PILATUS AIRCRAFT LTD, STANS, SWITZERLAND

SERVICE BULLETIN

Service Bulletin No: 27-009 Ref No: 137

FLIGHT CONTROLS - FLAPS INSPECT THE LEFT AND RIGHT, INNER AND OUTER, FLAP HINGE BRACKETS

Inspection of the Flap Hinge Brackets Figure 1, Sheet 1 of 2

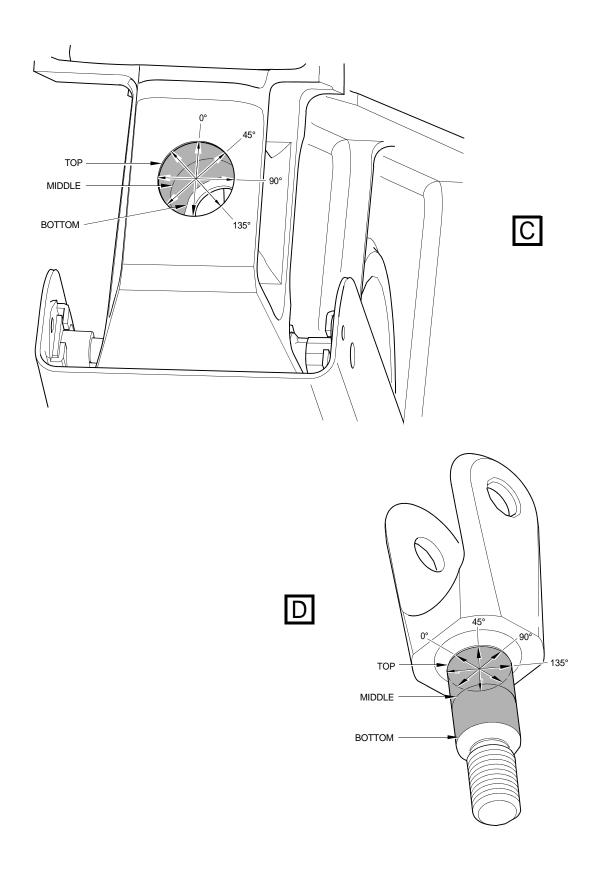
- (1) At the inner flap-hinge bracket (5) on the left flap (1):
 - (a) Remove the nut (6) and the washer (7).
 - (b) Remove the rod-end (2) and the washers (3) and (4) from the hinge bracket (5).

- (c) Attach the washers (3) and (4) to the rod-end (2) and make a note of which flap bracket they were installed on.
 - (d) Clean the rod-end (2) and the bore in the inner flap-hinge bracket (5) with the absorbent paper (Material No. P02-031) made moist with the solvent (Material No. P01-010).

- (e) Look for corrosion in the bore of the hinge bracket (5) and on the rod-end (2), as shown in Fig. 1 (Ref. SRM, 51-00-00-00A-284A-A).
- (2) Do Step 3.B.(1)(a) thru Step 3.B.(1)(e) again for:

- (a) Remove it (Ref. SRM, 51-20-01-00A-250A-A).
 - (b) After the corrosion has been removed:
 - <u>1</u> Measure the minimum diameter, in twelve positions, of the shank of the rodend (2) as shown in Detail D and make a note of the dimensions in Table 1.

- <u>a</u> If the minimum diameter, at one of the twelve positions, is 12,699 mm or less, contact Pilatus Customer Technical Support (MCC), Fax: +41 (0) 41 619 67 73, Email: Techsupport@pilatus-aircraft.com.

- 2 Measure the maximum diameter, in twelve positions, of the bore of the hole in the inner flap-hinge bracket (5) as shown in Detail C and make a note of the dimensions in Table 2.
 - If the maximum diameter, at one of the twelve positions, is 12.792 mm <u>a</u> or more, contact Pilatus Customer Technical Support (MCC), Fax: +41 (0) 41 619 67 73, Email: Techsupport@pilatus-aircraft.com.
 - If the maximum diameter, at all of the twelve positions, is less than b 12.792 mm, continue with this Service Bulletin from Step 3.B.(4).
